Clonburris T3

Road Safety Audit Response Report

CLB-T3-ZZZ-SW-DTM-RP-DBFL-CE-0005

April 2023

Location (S8) – Residential Local Street

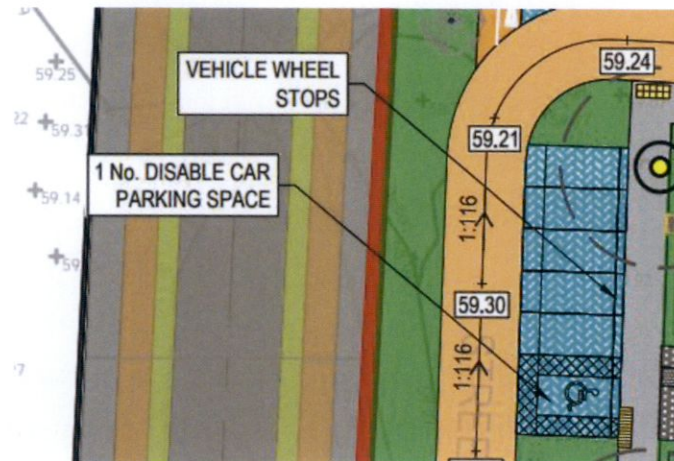
The auditors are concerned that the proposed 6m width for the 'Local' residential street is excessive compared to DMURS recommendation and could result in higher vehicle speed. This a concern in the area as cyclists are likely to be present on the road carriageway in this general area when travelling between the segregated cycle track (to the south) and the shared ped/cycle path along the site's northern boundary.

The street should be narrow to meet the DMURS recommendations.

Consideration should also be given to implementing signage that would provide advanced cycle warning to the drivers of the presence of cyclists on the carriageway in this area.

Street 14 has been converted to a Homezone of 4.8m width, which will assist in managing vehicle speeds and ensure cyclist safety. Street signs warning motorists of cyclists have also been included on the roads layout CLB-T3-95-SW-DTM-DR-DBFL-CE-1201.

Comment (C2) – Need for Controlled Pedestrians Crossings

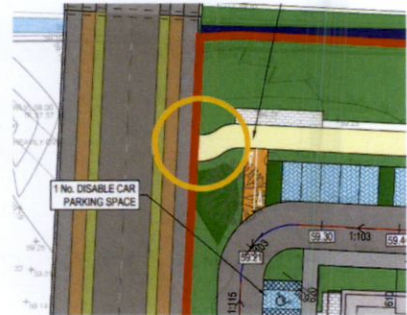
Further to C1, uncontrolled crossing is provided at the site access junction. The auditors feel that there is a need for controlled crossing for pedestrian and cyclists at this location due to anticipated high number of pedestrians and cyclists using the facility.

The Link Street adjacent to the proposed development has been granted planning under a separate planning application and has been deemed compliant.
